**Report to the Future Melbourne (Planning) Committee**

Agenda item 6.1

**Planning Permit Application: TP-2018-527**  
**360 Little Bourke Street, Melbourne**

**4 December 2018**

2 West Elevation  
1:200

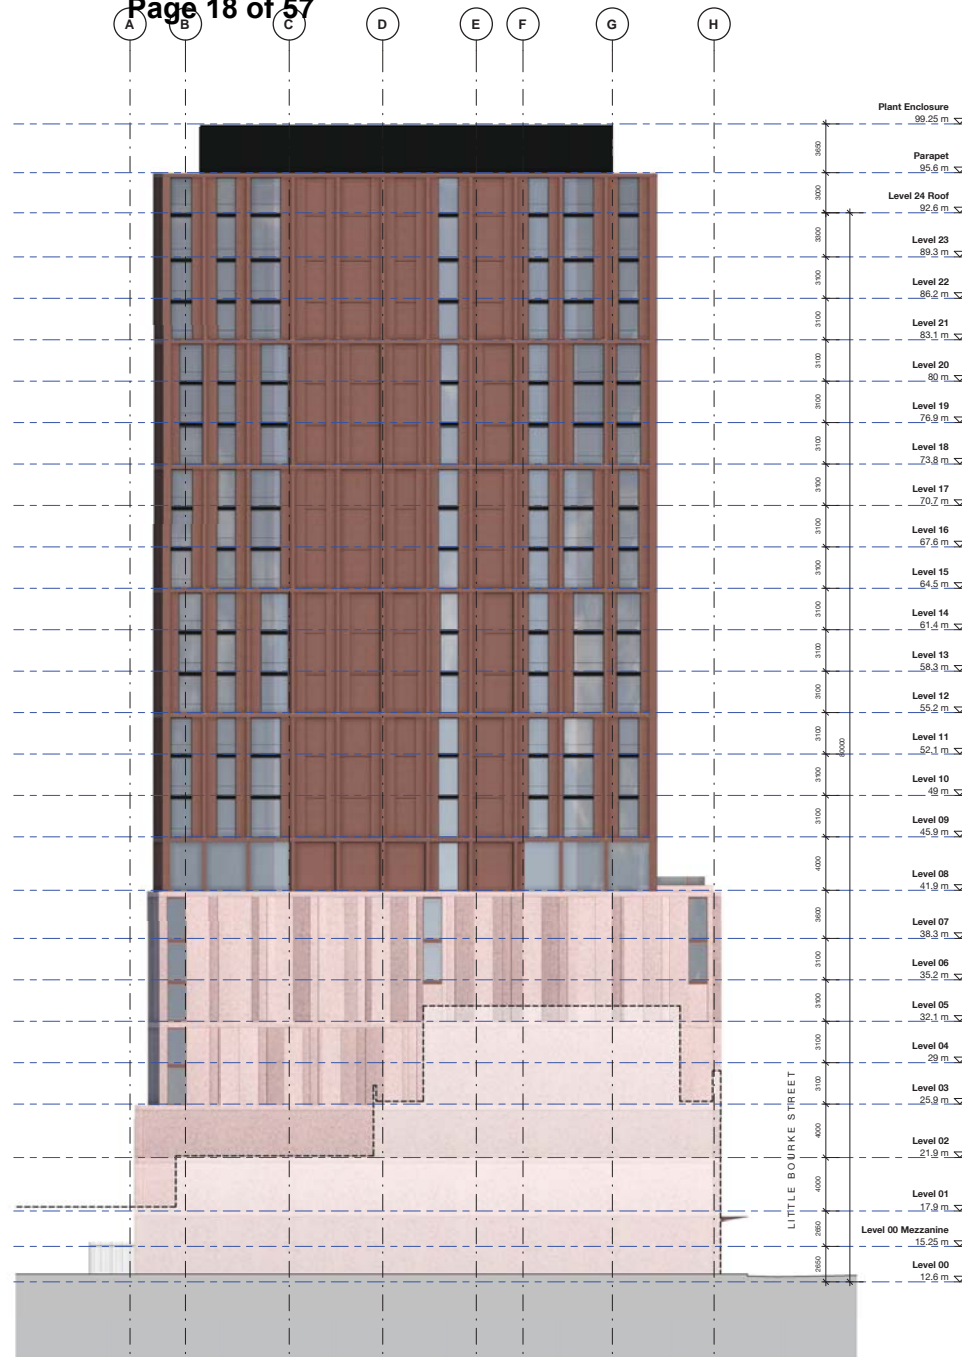
- The building has been considered in the round and all visible sides have been designed to a high standard to provide visual interest. The west elevation is articulated with window openings and the same façade language, albeit in a panelised form.

A S173 Agreement is recommended for the windows/ openings on the west boundary to protect the equitable development of the adjoining property.

7. Prior to the commencement of the development, including demolition and bulk excavation on the land, the owner of the land must enter into an agreement with the Responsible Authority pursuant to Section 173 of the Planning and Environment Act 1987. The agreement must provide the following:
  - a) The windows/openings on the western boundary must be removed when the adjoining property is further developed in a manner that the Responsible Authority considers would affect these windows/openings.

Transition in street wall

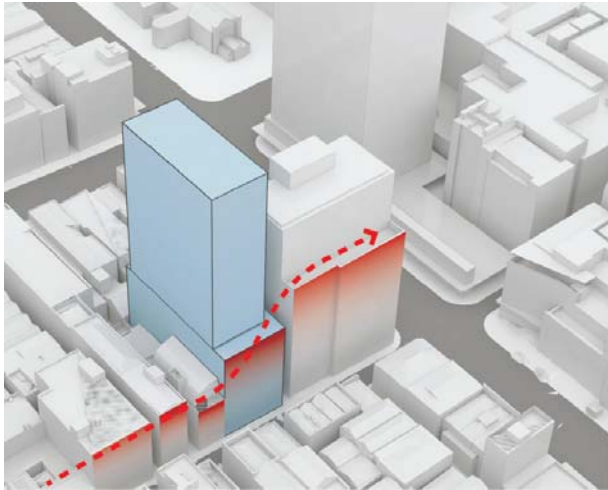
The street wall satisfies the modified requirement and achieves the design objectives and built form outcomes of DDO10. It provides an appropriate graduation in height between Nova Apartments (12 storeys) and Campton House (four storeys). It is appropriately articulated with a vertical expression to respect the rhythm of the streetscape and reduce the perceived bulk and mass. The canopy, as shown on the revised renders, defines the ground floor, provides a human scale and reinforces the intimate streetscape.

While the site is 20.1m wide and presents an opportunity to provide a step in the street wall, the podium is acceptable as proposed given the rhythm of the street, which includes a mix of fine grain and wider sites.

6.8m separation

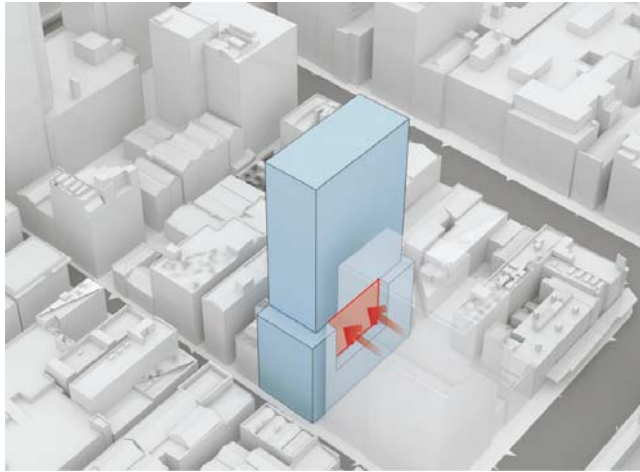
The development has an eight storey podium and a 16 storey tower (24 storeys in total). The podium has a 20.8m long x 3.2m deep inset on Levels 3 to 6, which increases the separation between the buildings to 6.8m. The tower is setback 5m from the centre of the lane, which provides a 6.8m separation between the buildings.

The 6.8m separation provides adequate light, outlook and privacy to the adjoining dwellings and the hotel rooms, having regards to:

- The inner city context.
- The north-south orientation of Whitehart Lane.
- The siting and massing of Nova Apartments, which is largely built to the boundary.
- The layout of the dwellings in the five storey addition to Nova Apartments, which have north and south facing windows.
- The nature of the uses; dwellings and residential hotel.

West elevation

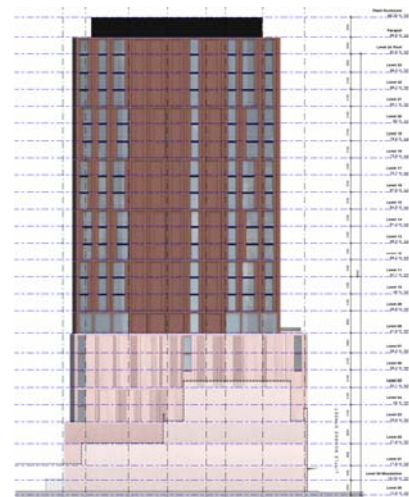
Campton House is a four storey building with two additional recessed upper levels and terraces at the front and rear. The building contains a retail unit and three dwellings.

The existing building has a six storey boundary wall to Campton House.
